## MEMORANDUM

RE: 5182 Port Chilkoot Distillery

**Requested Action:** Licensed premises diagram change

**Form AB-14: Licensed Premises Diagram Change**

DISTILLERY PLOT PLAN  
SCALE 3/32" = 1'0"

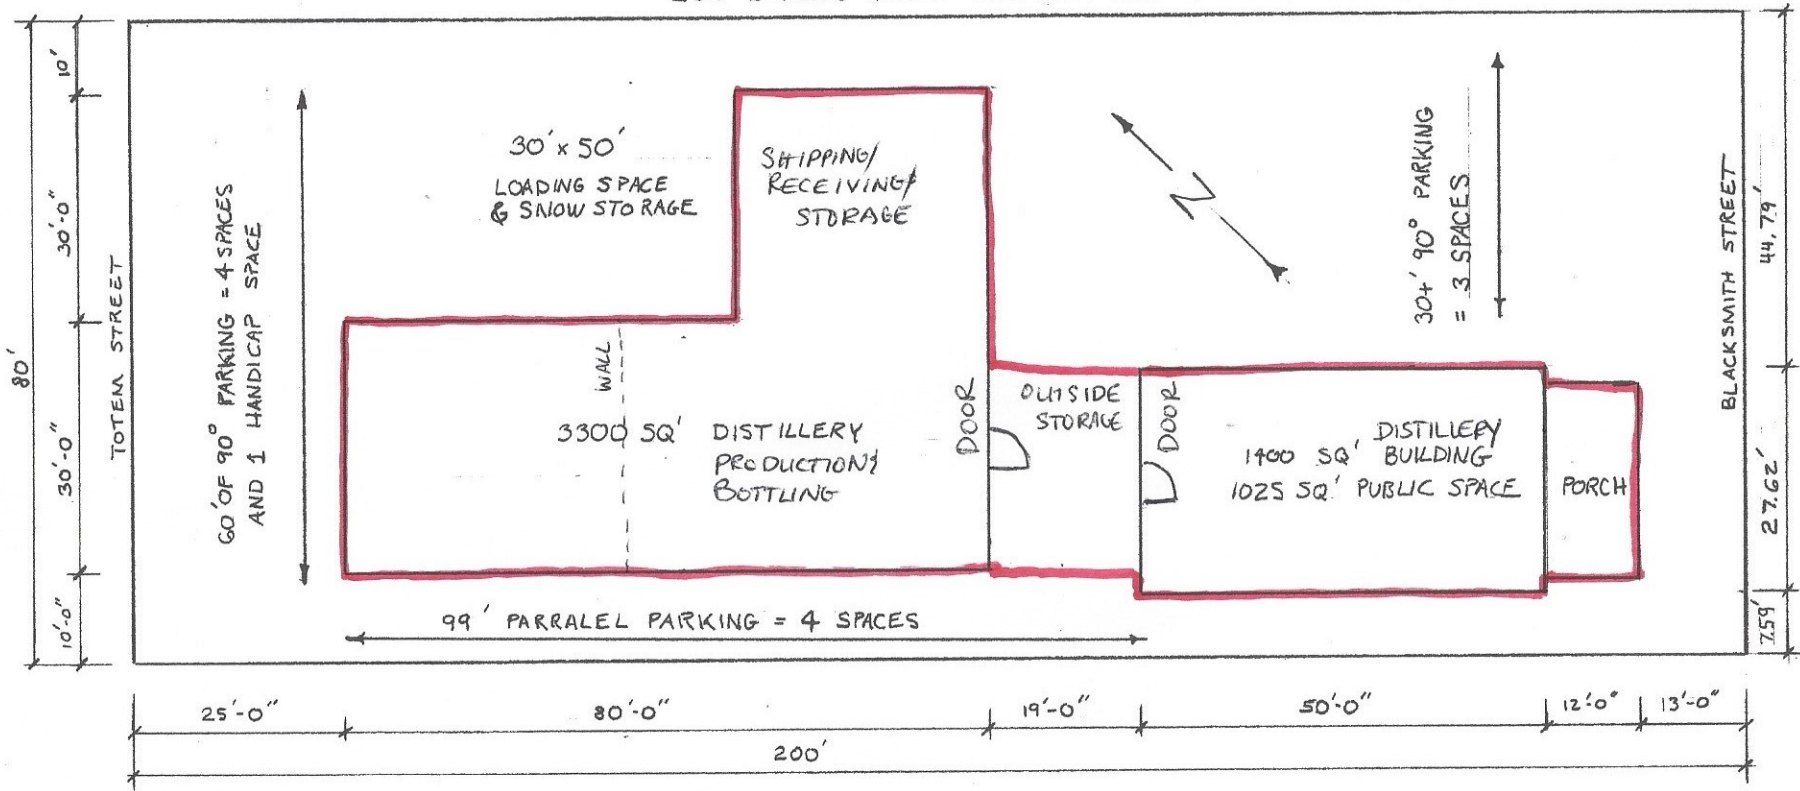
**Background:** This distillery license is requesting to amend its licensed premises diagram to add a second building. The licensee plans to move the distillery tasting room into the second building. Originally the licensee submitted a plan showing each building as separate licensed premises. I denied that request based on 3 AAC 304.185(a) which requires the licensed premises to be one area. The licensee returned the attached diagram, proposing to license the unused space between the buildings.

Although I have by no means reviewed every single premises diagram of all  $\pm 1,800$  licenses, I can't think of an outside area that is licensed premises that isn't being used as an onsite consumption area. I recommend against the board approving the use of outside area to connect two or more buildings to be a single licensed premises. Keep in mind that the only requirement to distinguish between licensed and unlicensed areas is 3 AAC 304.185(d) which says, "If a business establishment or facility consists of both licensed premises and an unlicensed area, the licensee shall clearly segregate the licensed premises and the unlicensed area." This guidance is not very specific, and various licensees have attempted to stretch the meaning of the regulation quite far. This approval would set a precedent and potentially allow situations where the limits of the premises, and thus AMCO's regulatory authority, are not clear.

**Staff Rec.:** Deny the diagram change

DISTILLERY PLOT PLAN  
 SCALE 3/32" = 1'0"

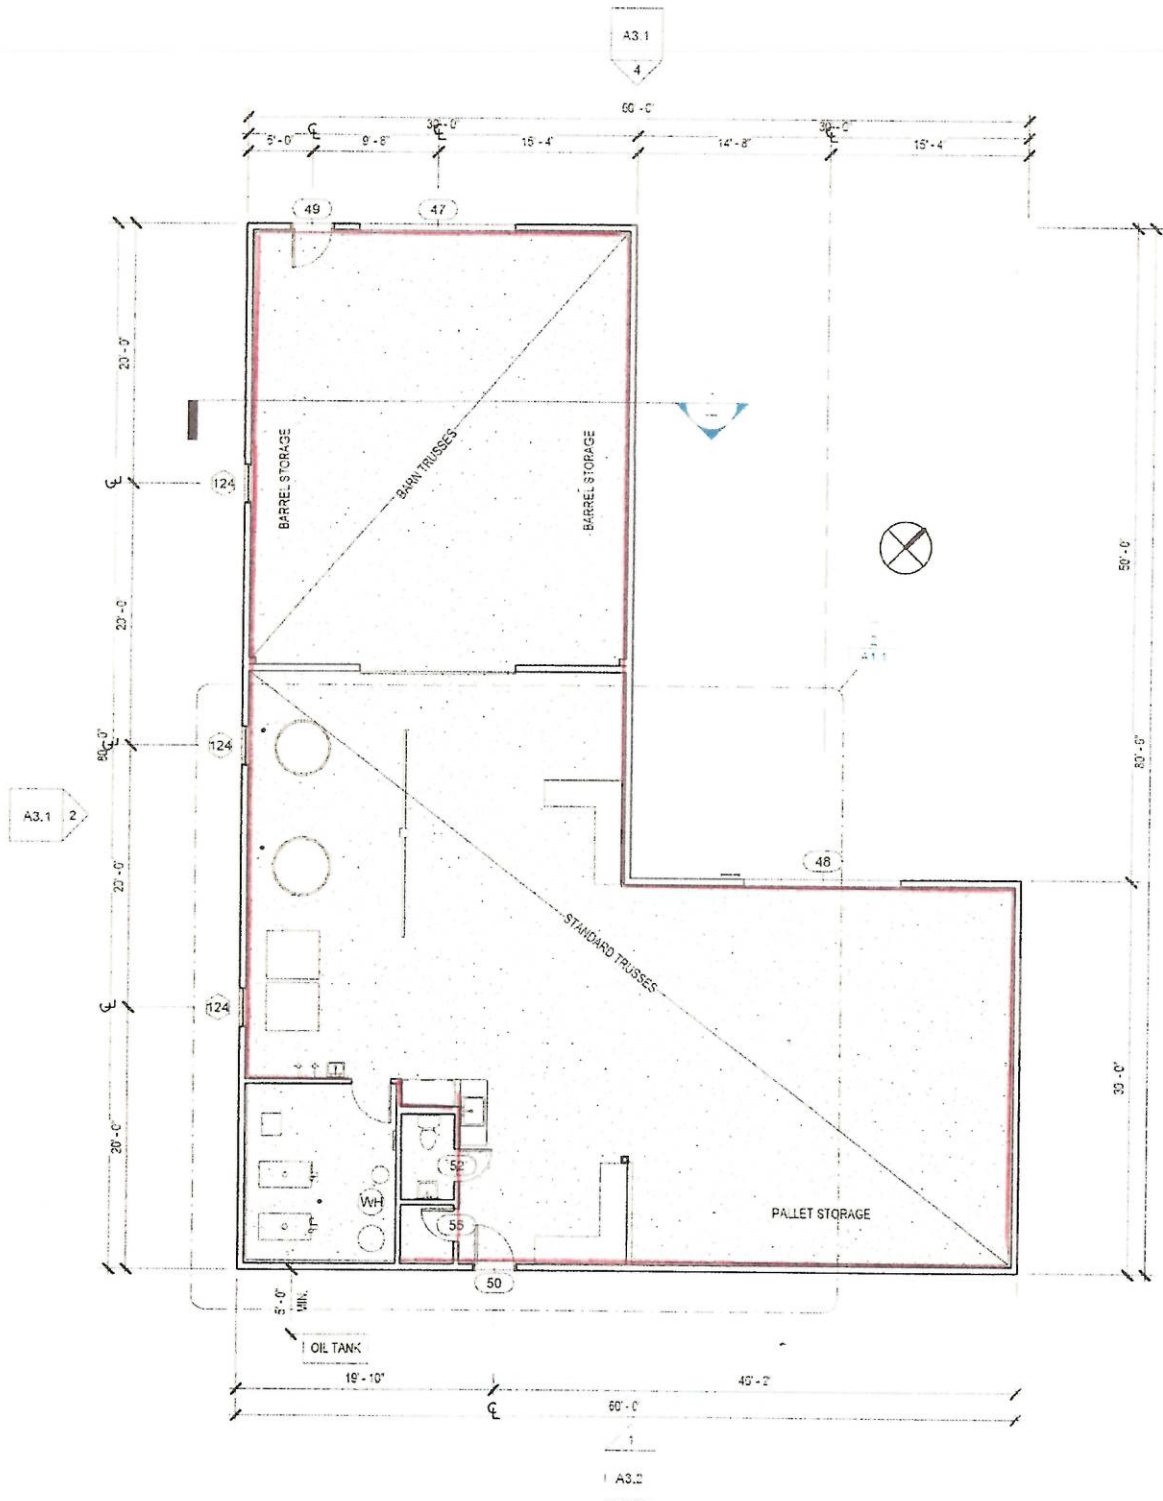
This proposed area would not be in compliance with 3 AAC 304.185 Licensed Premises
